SYMBOL OF QUALITY AN ISO 9001 COMPANY	JINDAL ALUMINIUM LTD. BANGALORE-560073 (INDIA)	NAME		DATE
		DRAWN	J.P.KAUSHIK	06-11-2009
1. ALL DIMENSIONS ARE IN mm. 2. ROUND OFF ALL SHARP CORNERS WITH 0.40 mm. 3. TOLERANCES WILL BE AS PER IS:2673-2002 UNLESS OTHERWISE SPECIFIED		CHECKED		
		APPROVED		
PARTY'S NAME AL-CAN EXPORTS PVT. LTD., THANE		SCALE		1:1
		AREA mm ²		4461.062
PARTY'S DRAWING No. AS PER SPECIFICATION		PERIMETER mm.		477.522
		WEIGHT kg/m		12.045
ALLOY & TEMPER 6061 'O'		DRAWING No.		SECTION No.
		P-8939-1		-
DESCRIPTION ROUND TUBE		13476		13476 (ISSUE-4)

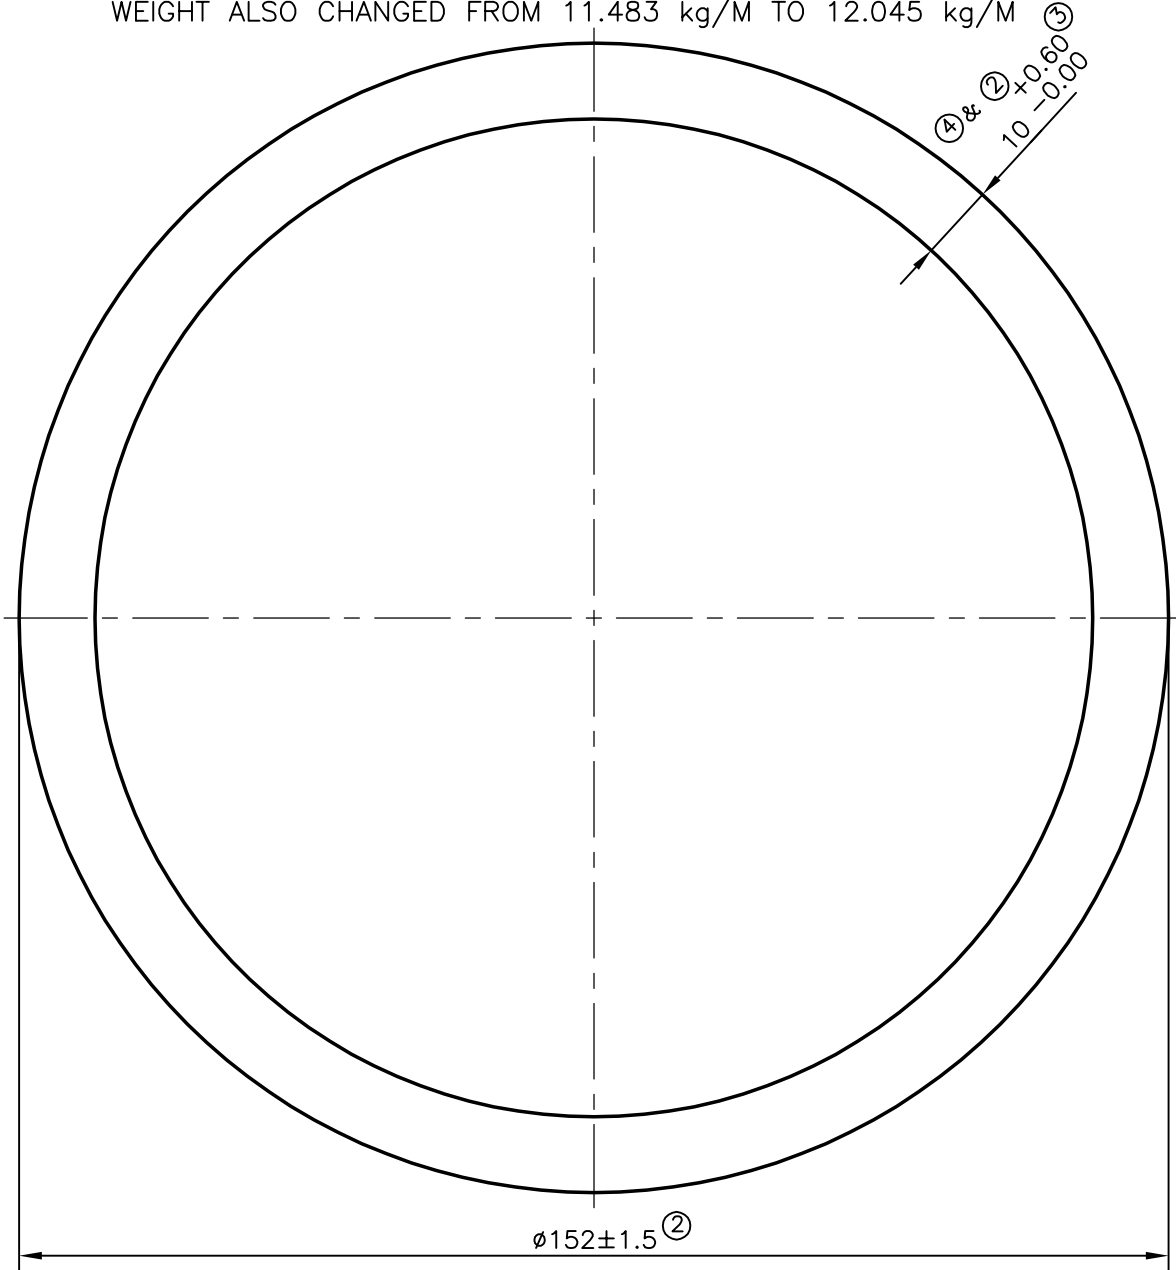
P-8939-1	ISSUE-2	THICKNESS CHANGED FROM 9.0 TO 9.5
13476		TOLERANCE CHANGED FROM $+0.80$ TO $+0.50$ -0.00 TO -0.30
	ISSUE-4	O D TOLERANCE CHANGED FROM ± 1.20 TO ± 1.5

ISSUE-4
 THICKNESS CHANGED FROM 9.5 TO 10
 WEIGHT ALSO CHANGED FROM 11.483 kg/M TO 12.045 kg/M

ISSUE-3
 TOLERANCE CHANGED FROM $+0.50$ TO $+0.60$
 -0.30 TO -0.00
